DRAWING NO. REV. C
D3290 SHEET 1 OF 2
TITLE SCALE
REPLACEMENT WINDOW ASSEMBLY 1:5

DRAWING NO. D3290	TITLE REPLACEMENT WINDOW ASSEMBLY	REV. C	DART AEROSPACE LTD ENGINEERING ORDER		D.E.O. NO. D3290-C-1	SHEET NO. SHEET 1 OF 1	SCALE NTS
DRAWN <i>GP</i>	CHECKED <i>J</i>	MFG. APPR. <i>E</i>	APPROVED <i>MD</i>	DE APPR. <i>#</i>			
DATE 09.09.18	DATE 09.09.18	DATE 09.09.18	DATE 09/09/21	DATE 09/09/21

PURPOSE:

CHANGE MATERIAL THICKNESS OF D3290-1 FRAME TO 0.063 FROM 0.040. REF PAR 09-033.

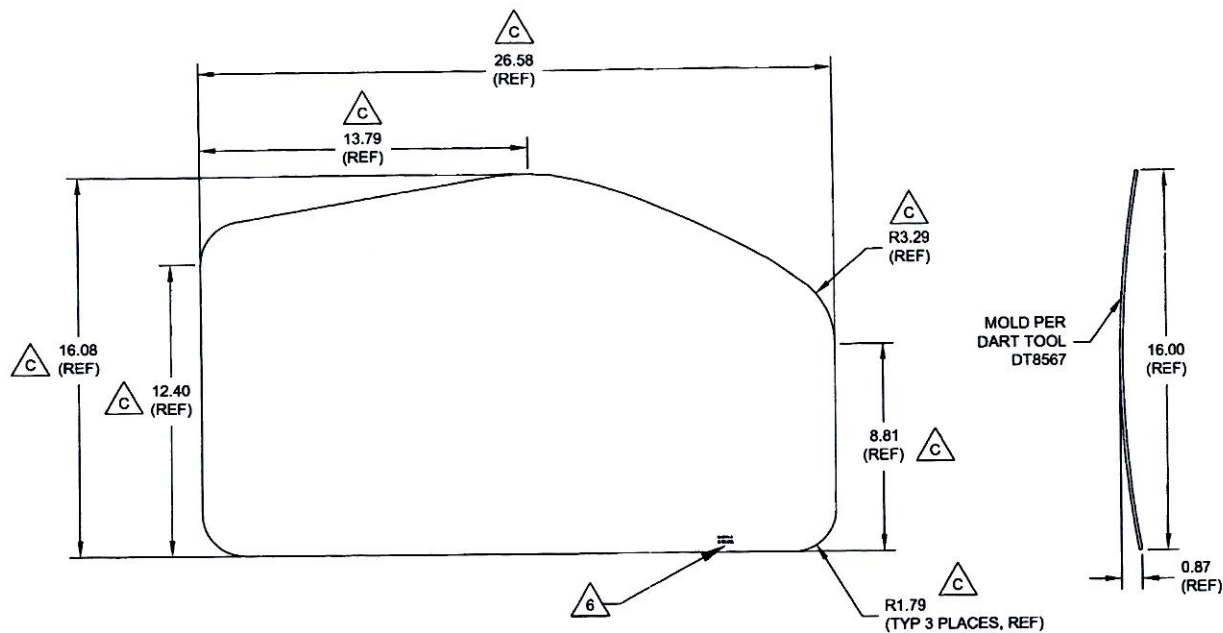
MATERIAL CALL-OUT OF D3290-1 FRAME ON SHEET 1 IS AMENDED AS FOLLOWS:

- 1) MATERIAL: 6061-T6 (OR 6061-T62) ALUMINUM SHEET ~~0.040 THICK~~ 0.063 THICK (REPLACE)
 PER AMS-QQ-A-250/11 OR AMS 4025 OR AMS 4027
~~(REF. DART SPEC. M6061T6S.040)~~ REF. DART SPEC. M6061T6S.063 (REPLACE)
 OR
 5052-H32 ALUMINUM SHEET ~~0.040 THICK~~ 0.063 THICK (REPLACE)
 PER AMS-QQ-A-250/8 OR AMS 4016
~~(REF. DART SPEC. M5052H32S.040)~~ REF. DART SPEC. M5052H32S.063 (REPLACE)
